Attachment 2 to PLA-6242
Non-Proprietary Version of the Request for
Additional Information Responses

NRC Question 1:

In reference to the response to the NRC staff's Request for Additional Information (RAI) 3 in letter PLA-6167 dated April 27, 2007, PPL is requested to clarify the following:

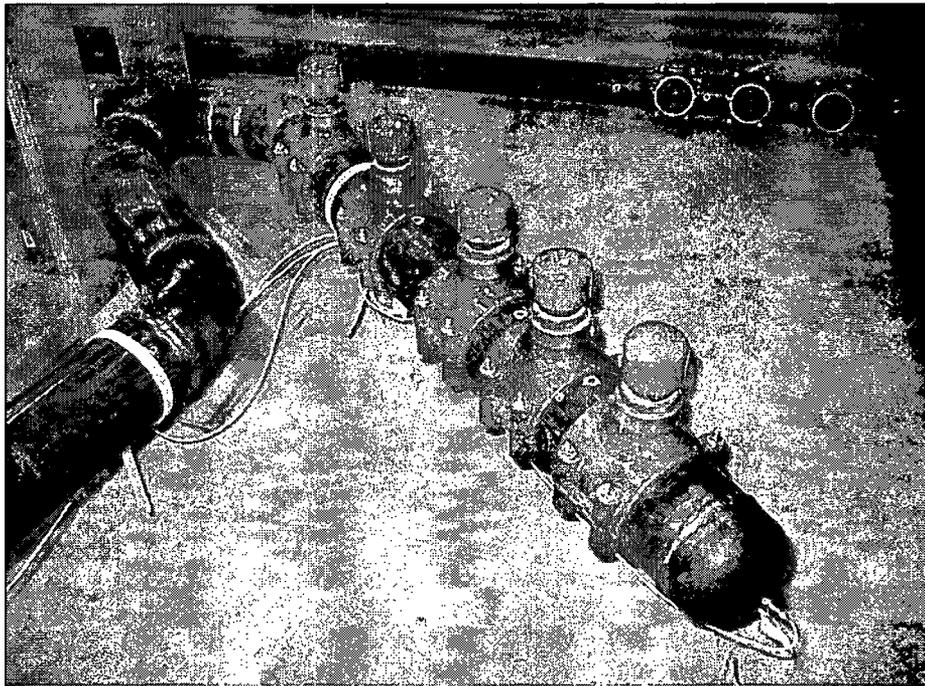
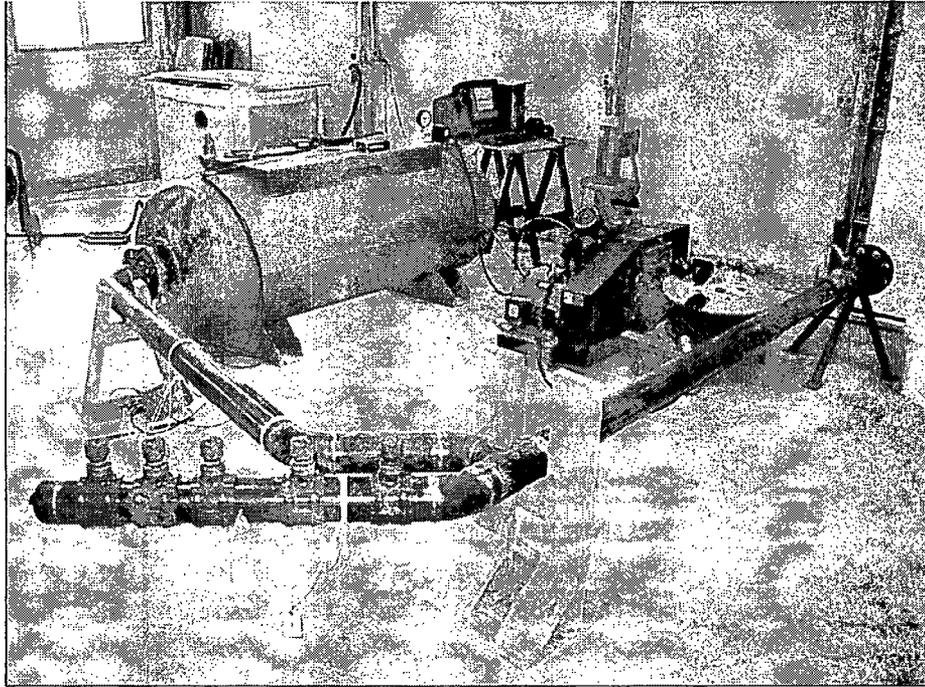
- (c) In its response to RAI 4 (and RAI 31), PPL supplied more details on the MSL geometry. It seems that the lower strain gauges on steam lines A and D are very close to (1) the T-junction at the mouth of the dead leg and (2) to a pressure node of the 16 Hz component. Concerning Item (1), PPL is requested to explain how it accounts for the effect of the pipe stiffening (being close to a T-junction) when relating the pipe strains to acoustic pressure. Regarding Item 2, the lower strain gauges on Lines A and D are nearly "blind" to the 16 Hz component, which is the

strongest dynamic loading on the dryer. Since PPL is planning to use MSL measurements to evaluate the dryer stresses for the last two steps of power ascension to EPU of Unit 1, the measurement accuracy and uncertainties of the lower strain gauges should be re-assessed. First, the lower strain gauges are blind to the 16 Hz component and they are also close to the T-junction, which influences the conversion factor. PPL is requested to explain whether the lower strain gauges will be repositioned (away from the pressure node) or if additional strain gauges will be installed on lines A and D (i.e., use a 3-location measurement method for MSL pressures).

- (c) There are no plans to reposition or install additional MSL strain gauges.

]] In addition, when the strain gauges were installed, ultrasonic measurements were taken at their locations to determine the actual pipe thickness. These thickness measurements were used in the determination of the micro-strain to pressure conversion factors.

During the Unit 1 power ascension to 107% CLTP, data will be concurrently recorded from the dryer instrumentation, and main steam line strain gauges. This data will be used to assess the uncertainties associated with the entire suit of steam line strain gauge readings. If this review indicates that the relocation of the main steam line strain gauges is warranted, this action will be accomplished prior to increasing power above 107% CLTP.

**FIGURE 2-1 - Photographs Of Susquehanna Blowdown Facility:
Entire Scaled Main Steam Lines A & D (Top); and
Deadheaded Branch Line (Bottom)**

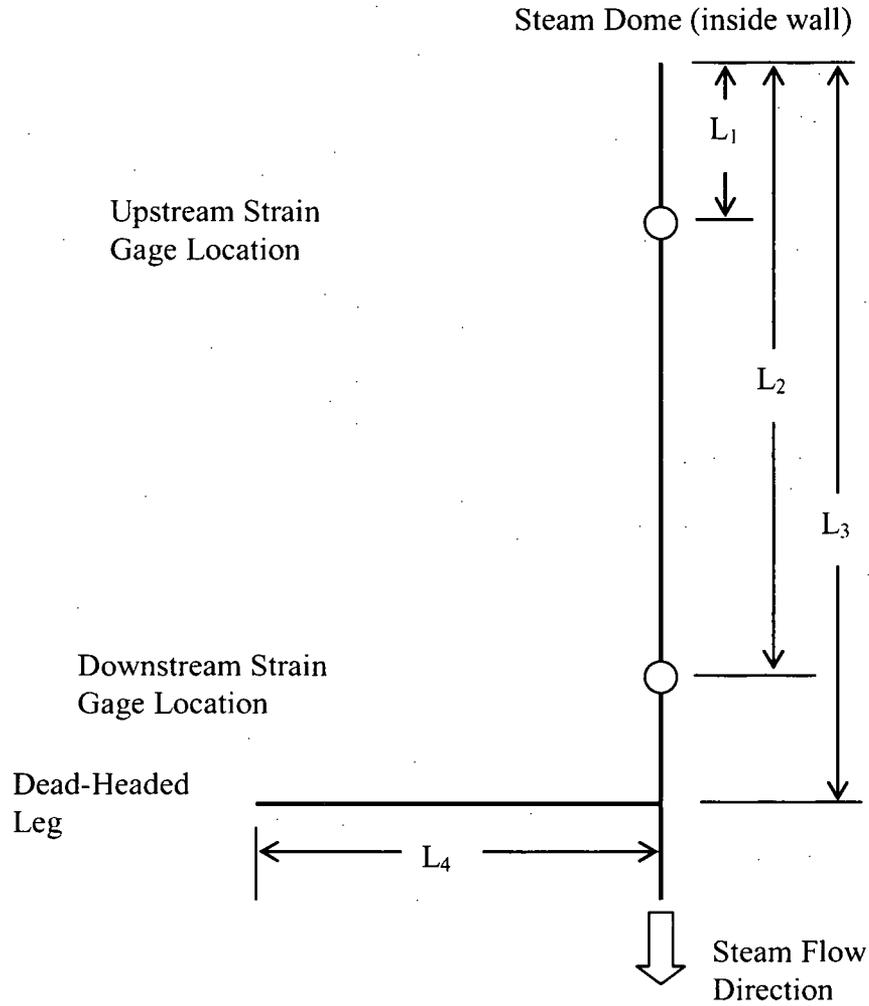
- (a) In the response to NRC staff's RAI 4 in letter PLA-6167 dated April 27, 2007, PPL supplies pressure time signals measured during the scale model testing (SMT) and inside the dead leg attached to line A (or D). The signals appear to be in phase, which supports the supposition of a standing quarter wavelength inside the dead leg. However, PPL does not comment on why the normalized power spectral density (PSD) is lower at the end cap than at the midpoint of the dead leg (Figs A.19 to A.29 of Continuum Dynamics Inc. (CDI) Report No. 05-32, March 2006). These results contradict those shown in Fig. 8.2 of the same report, which shows higher root mean-square (RMS) pressure at the end cap. PPL is requested to explain this disagreement in the reported results.

- (b) PPL also refers to the turbulent eddies at the inlets of MSLs as the excitation source of the low frequency components (16 and 32 Hz). While this is a plausible excitation source, PPL neglects the possibility of flow excitation at the mouth of the dead leg. Simple calculations based on $f=16$ Hertz (Hz), $V = 153$ fps, and 24" diameter pipe, gives a Strouhal number of about 0.21. This is close to the critical value for this geometry (see Figs. 12 & 13 of paper by Peters & Bokhorst 2000, "Flow-excited pulsations in pipe systems with closed branches, impact of flow direction," in Flow-Induced Vibration, Balkema 2000). However, the geometry of the T-junction edge is crucial. PPL is requested to (1) evaluate this possible excitation source; (2) provide information on the geometry of the T-junction edge (sharp or rounded and at what radius); and (3) explain whether the geometrical details of the T-junction edges and the length of MSL A were properly modeled in the SMT study.

(b)(3) The one-sixth scale model was fabricated as near as practical to full scale. See the response for RAI 2(b)(2) above.
